**THE TENNESSEE VALLEY
AUTHORITY'S KINGSTON ASH SLIDE:
EVALUATION OF POTENTIAL
CAUSES AND
UPDATES ON CLEANUP EFFORTS**

HEARING
BEFORE THE
SUBCOMMITTEE ON
WATER RESOURCES AND ENVIRONMENT
OF THE
COMMITTEE ON
TRANSPORTATION AND
INFRASTRUCTURE
HOUSE OF REPRESENTATIVES
ONE HUNDRED ELEVENTH CONGRESS
FIRST SESSION

JULY 28, 2009

Peer Review of the AECOM Root Cause Analysis of TVA Kingston Dredge Pond Failure
Tennessee Valley Authority, Office of the Inspector General
July 2009 • Prepared by Marshall Miller & Associates, Inc.

Stage 1 - Initiation of Failure at North Side of Dredge Cell 2

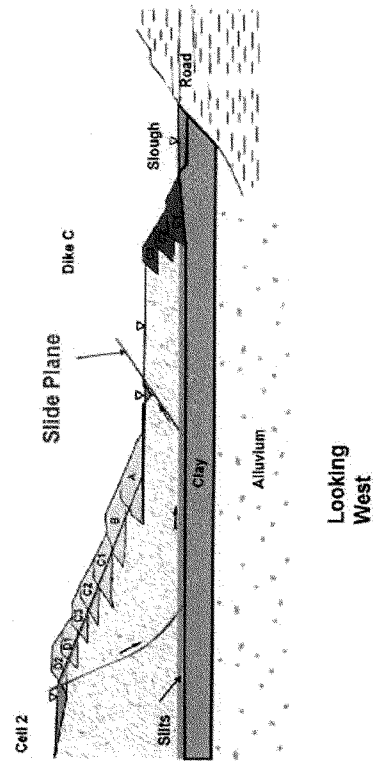
AECOM discussed the thin layer of slimes beneath the dikes of Dredge Cell 2, per item 3 above, which was discovered during its subsurface investigation (see Figure 2). Slimes do not exist beneath Dike C. Although the properties of this slime layer suggest it as a potential slippage surface based upon mathematical modeling, it is MM&A's opinion that it is not the only possible slippage surface. AECOM documented that slimes were not found in some locations, were not of consistent thickness, and had properties very close to those of the ash material itself.
